Mobile Intel® Pentium® 4 Processor-M

Specification Update

October 2003

Document Number: 250721-019

Figure 13. System Bus Reset and Configuration Timings

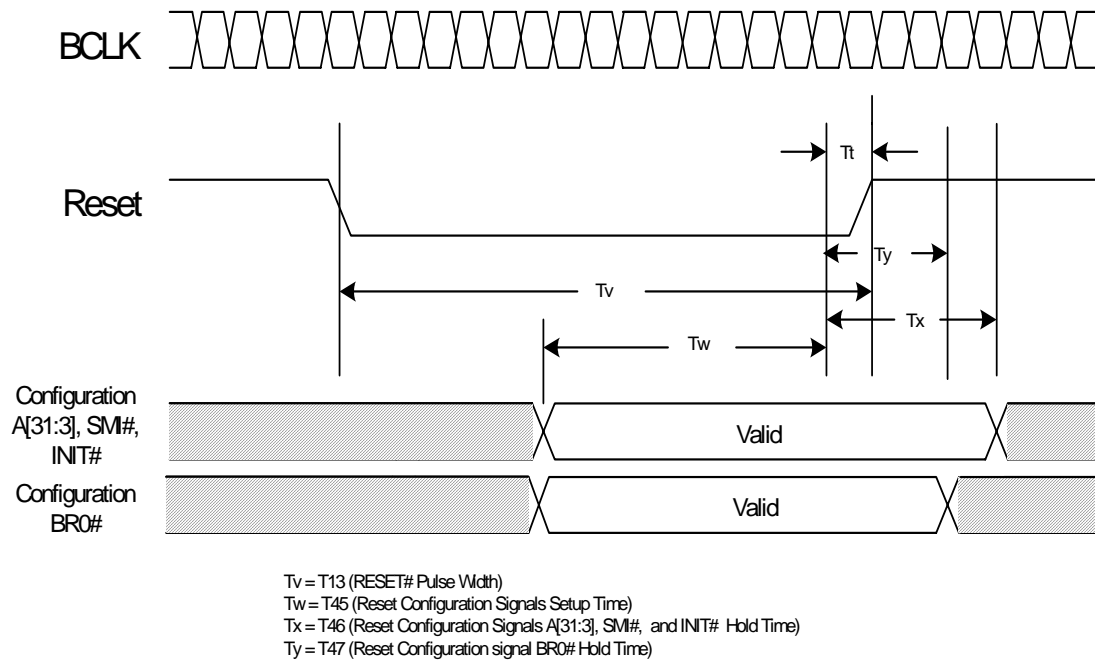
T2. BR0# Maximum Hold Time Specification Change

The BR0# maximum hold time has changed to 2 BCLKs. This change will be shown in the “System Bus AC Specifications (Reset Conditions)” table and “System Bus Reset and Configuration Timings” figure of the *Mobile Intel® Pentium® 4 Processor - M Datasheet*. This change will be incorporated in the next revision of the datasheet.

The following figure will be modified to reflect this change:

T# Parameter	Min	Max	Unit	Figure	Notes
T45: Reset Configuration Signals (A[31:3]#, BR0# INIT#, SMI#) Setup Time	4		BCLKs	13	1
T46: Reset Configuration Signals (A[31:3]#, INIT#, SMI#) Hold Time	2	20	BCLKs	13	2
T47: Reset Configuration Signal BR0# Hold Time	2	2	BCLKs	13	2

1. Before the deassertion of RESET#.
2. After clock that deasserts RESET#.
